Product Change Notification

Date Issued :	July 31, 2023	PCN Number :	514028
Reason for Change :	Packaging Method/Quantity Changing		
Description of Change :	Add alternative bag for Kits to make packaging process more flexible. Use additional packaging machine to increase capacity.		
Reason for Short Notice :	Capacity Increase		
Assessment of Change :	First Article Inspection		
Planned Implementation Date :	October 31, 2023		
Sample Availability Date:	August 10, 2023		
Internal Molex Qualification Date :	August 31, 2023		
Last date to request Samples by Customer :	October 02, 2023

Before Picture

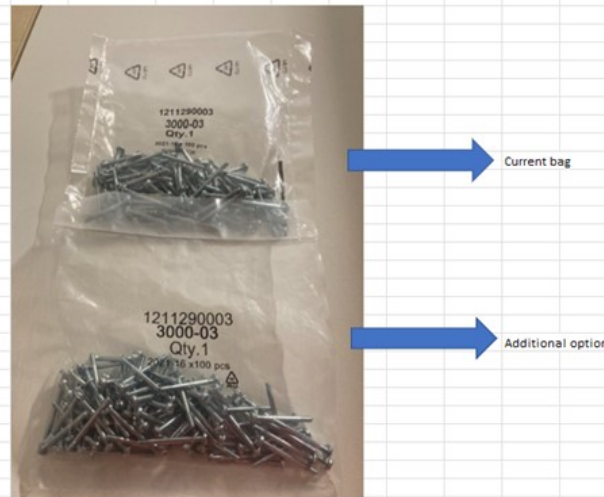
- Add alternative bag for Kits to make packaging process more flexible. Use additional packaging machine to increase capacity.
- Product Impact
 - No impact to fit, form or function
- Part Number Impact
 - see attached impacted parts list
